Office Action Summary

10/763,485

RUFF ET AL.

Exhibit A

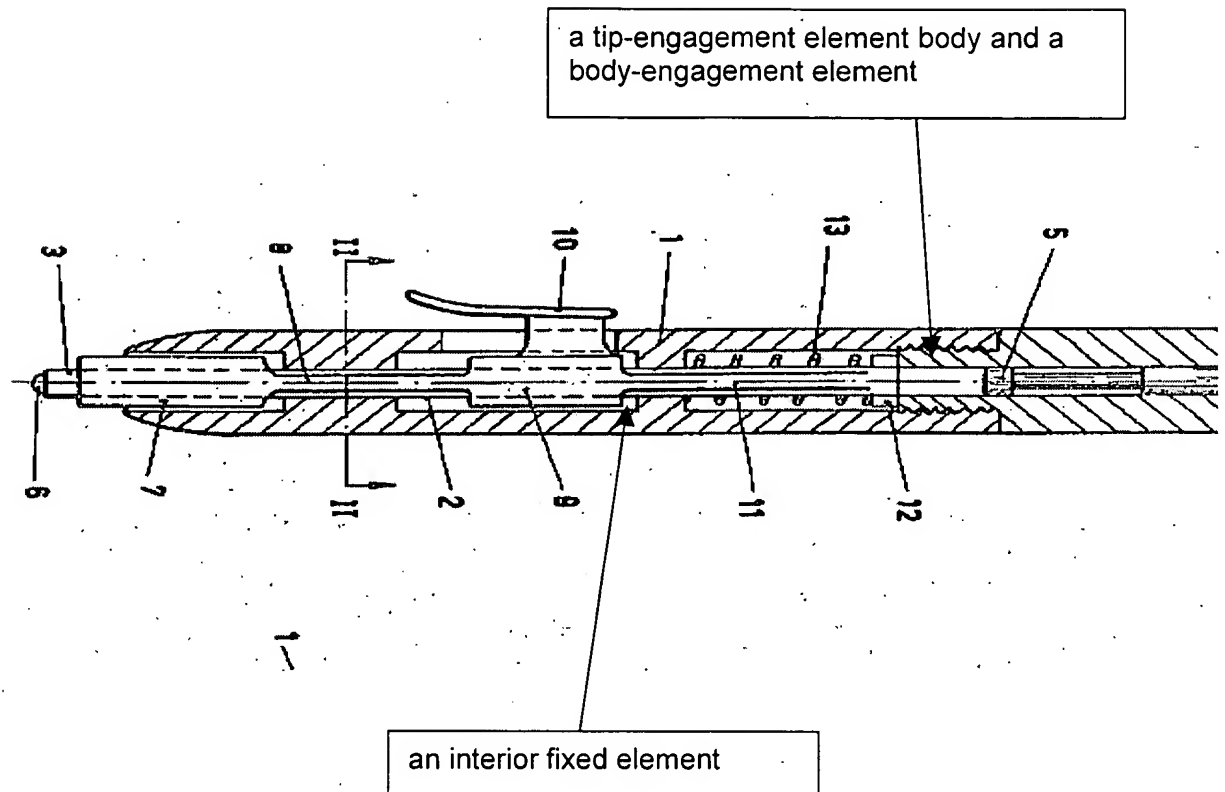
Re claim 5, Exhibit A (see next page) shows a tip-engagement element body and a body-engagement element includes a thread.

Re claim 9, Exhibit A (see next page) shows an interior fixed element to limit the tip.
